**ATTACHMENT 6A**

**Emergency Plan Marked-up Pages – Quad Cities Station**

Exelon Standardized Emergency Plan EP-AA-1000  
and  
Emergency Plan Annex EP-AA-1006

# **EXELON NUCLEAR**

Figure B-1a: Exelon Overall ERO Command Structure

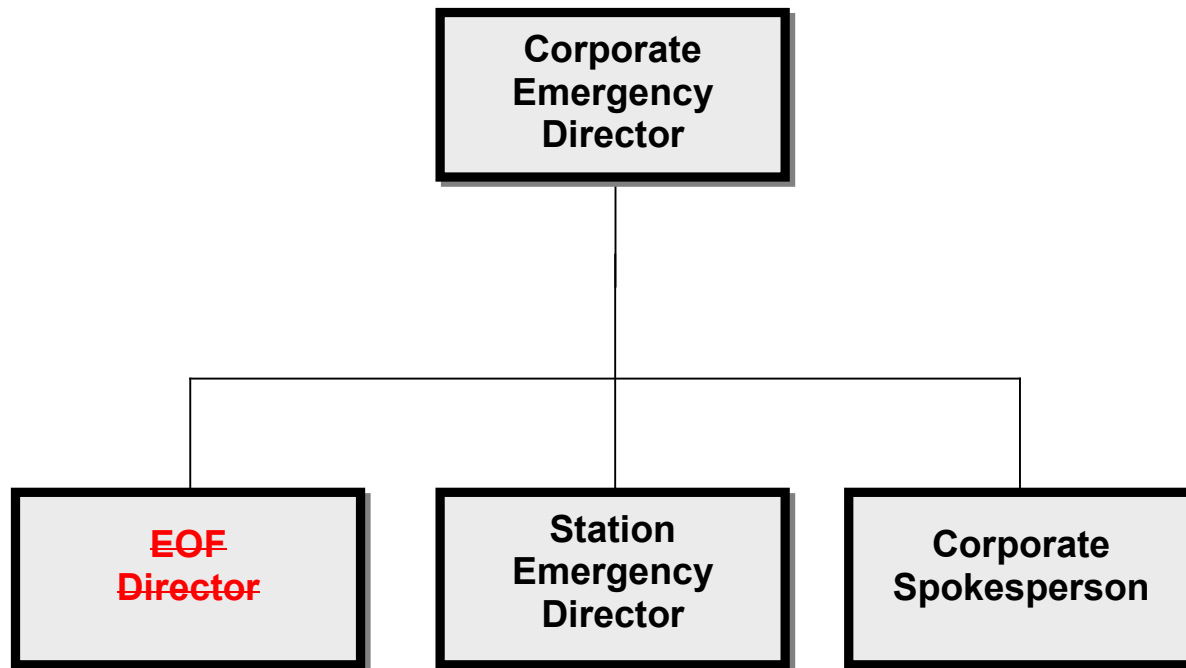
ERO staffing tables contained ~~within the station specific Annexin Appendix 5~~, lists the key positions of the ERO ~~and the supporting positions assigned to interface with federal, state, and county authorities~~. Figures B-1a through B-1d illustrates the overall emergency response organization. Section B.5 discusses specific responsibilities and the interrelationships for key positions.

Figure B-1b: Emergency Onsite Organization

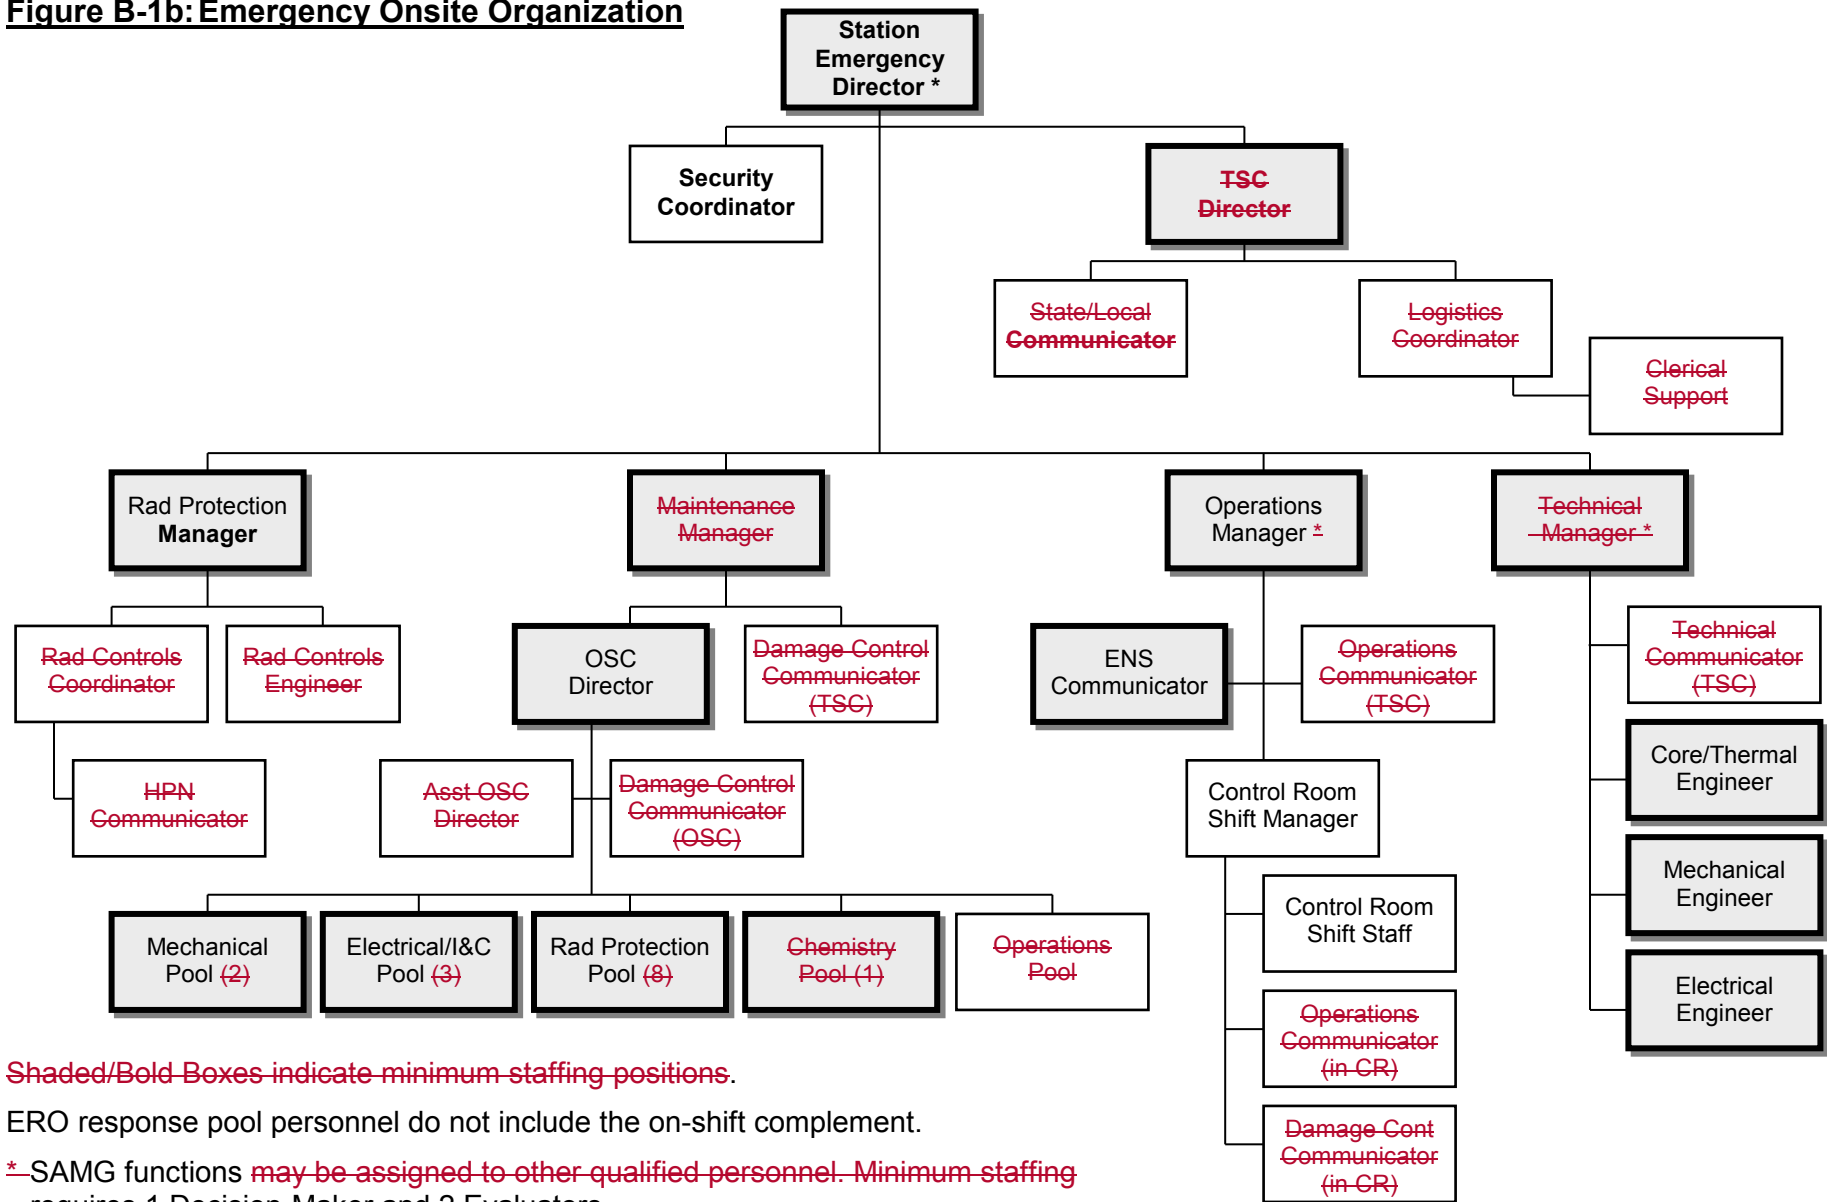
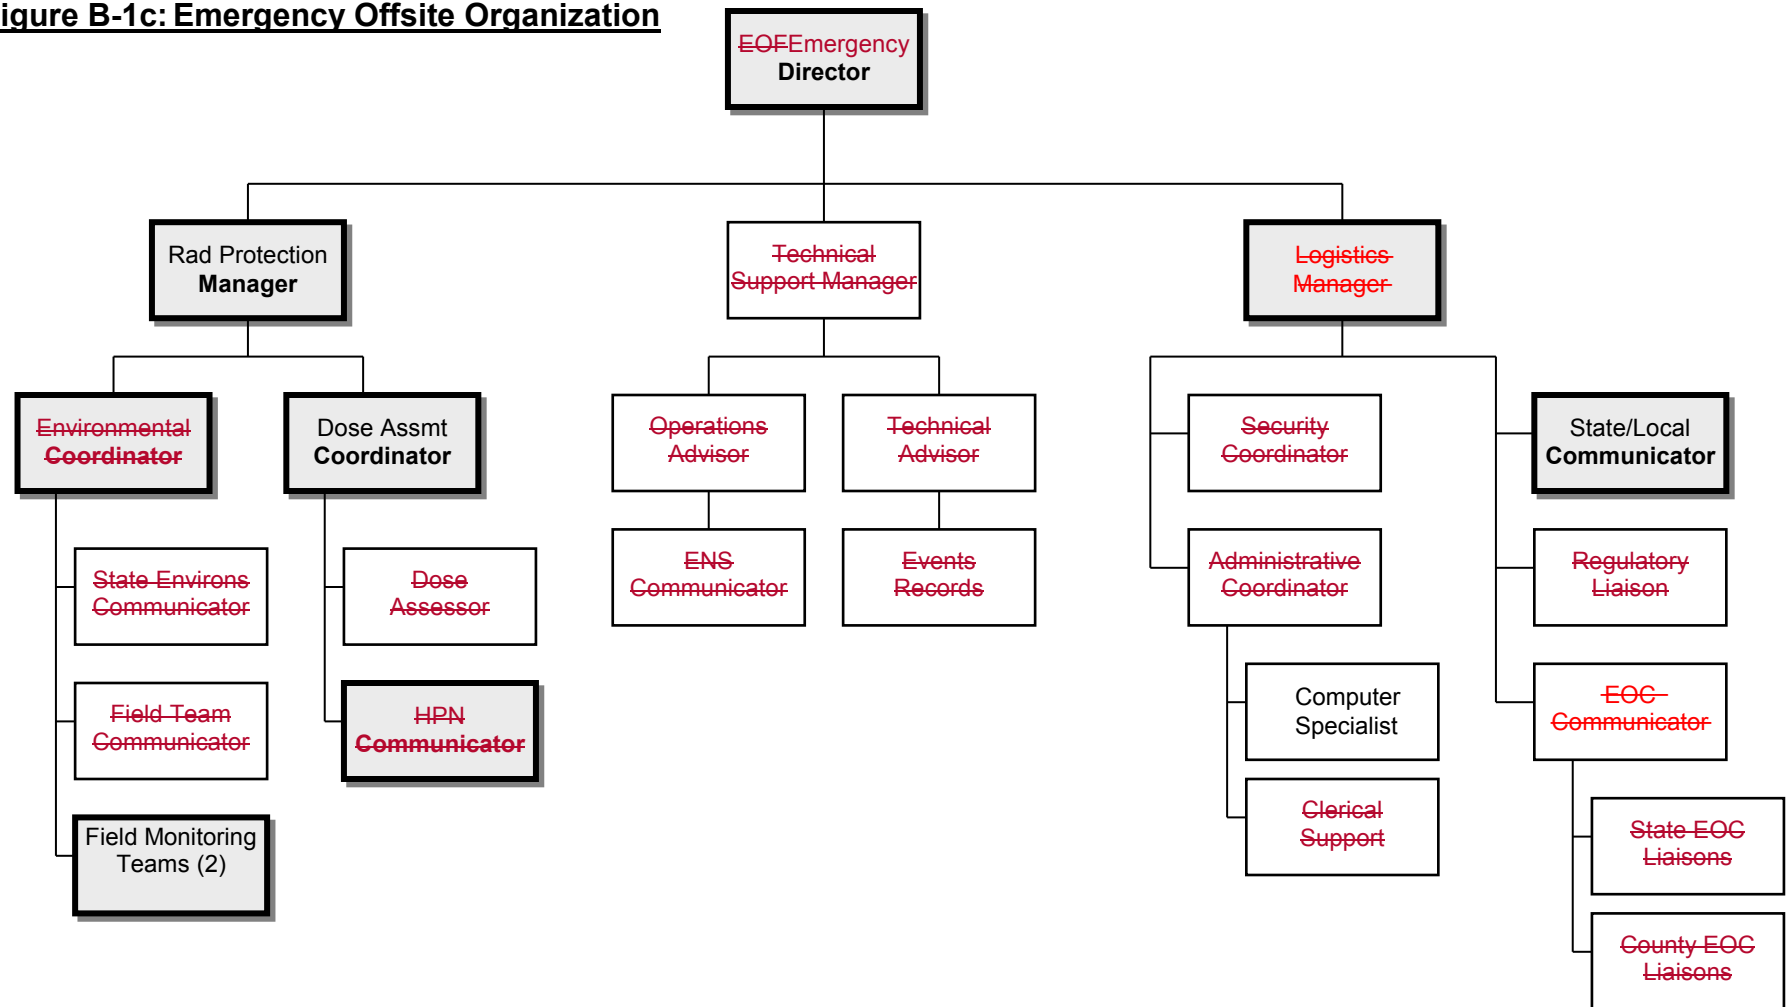
Figure B-1b illustrates the staffing and organization for the OSC.

**Figure F-3: NRC Communications for Nuclear Response**

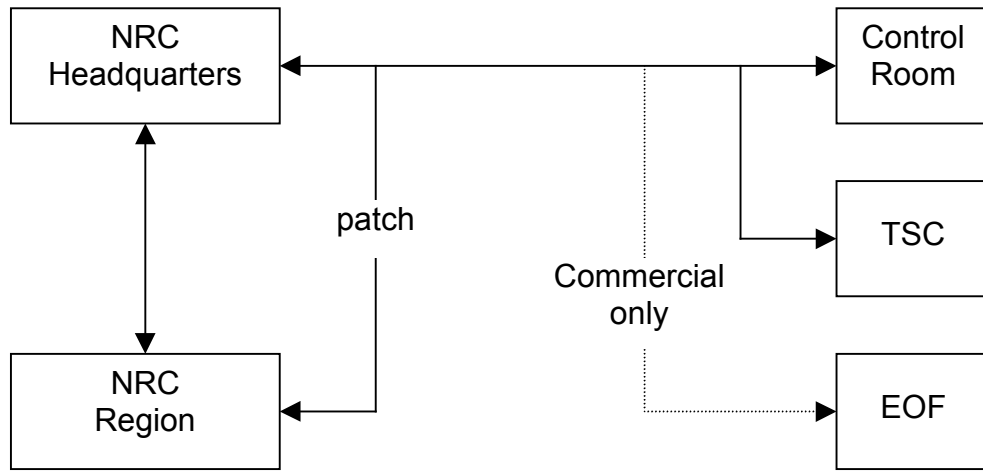
~~Health Physics Network (HPN): There also exists a separate dedicated telephone between the NRC, the TSC, and EOF for conveying health physics information to the NRC as requested or as an open line.~~
